From: Mitman, Jeffrey | NRC  
Sent: Monday, December 20, 2010 2:41 PM  
To: Ferrante, Fernando | NRC  
Subject: FW: Spillway Curve  
Attachments: Hydraulics - N values and Spillway Curves.pdf

Fernando, I'm not sure where I got the attached document. It appears to be an early evaluation by hydrologist in regard to the inundation analysis. My reason for sending it to you is the information on the JD spillways.

### Spillway Discharge Curve

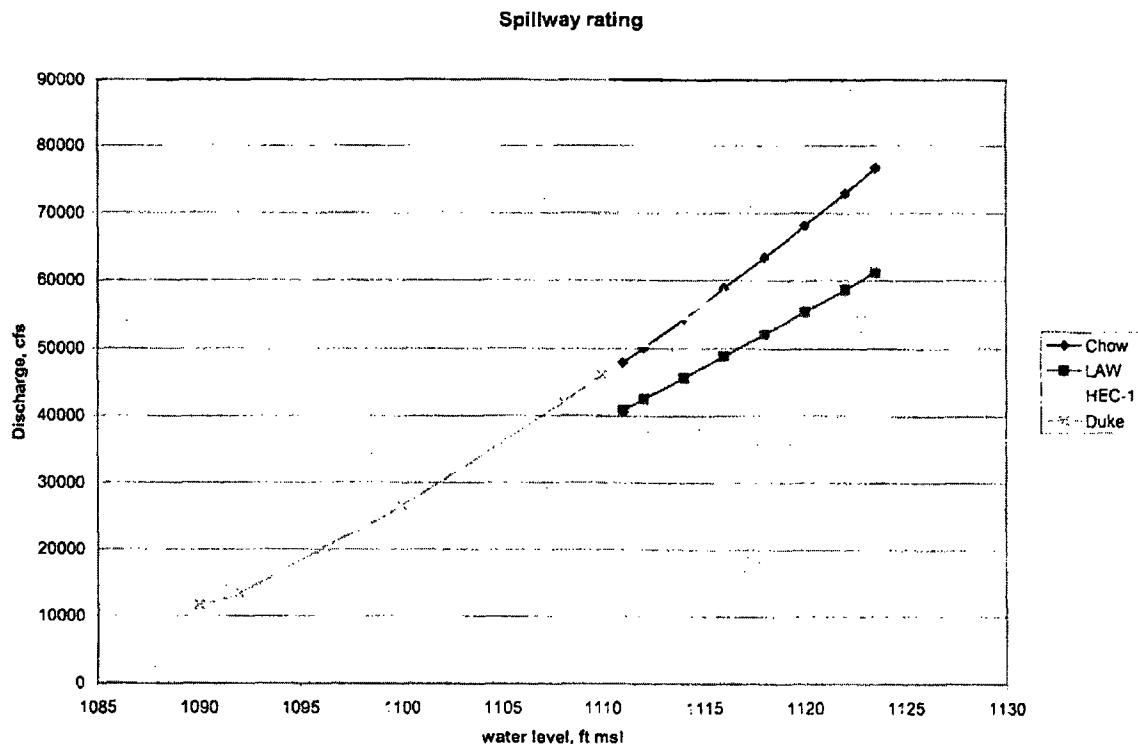
The spillway discharge curve as used in the LAW Engineering analysis could not be confirmed in this evaluation. The staff did calculate a spillway rating curve using information developed by the U.S Army Waterways Experiment Station and presented in Section 14.7 of Open Channel Hydraulics (Chow, 1959). In this method, piers in gated spillways are adjusted for using the relationship  $L = L_0 - K N H_e$  where:

With the spillway coefficient of discharge equal to 4.0,  $Q = 120 H_e^{1.5}$  for each bay of the spillway. This relationship corresponds approximately to the discharge curve by Duke used by FEI in the FERC report (2004) presented in this report. The discharge determined in the original study evaluated by AEC approximates the value that would be determined from this relationship (72,000 cfs as compared to 73,660 cfs).

The staff also considered the methodology presented in the HEC-1 program manual. Using this methodology, a different shaped curve was determined. Also, the original rating curve ended at

el 1123.5 because the low chord of the bridge is at this elevation and flow out of the reservoir changes to orifice flow at this level. Because of the higher water levels to be evaluated, the rating curve was adjusted for orifice flow and added to the program. All three rating curves are shown in Figure \_\_\_\_.
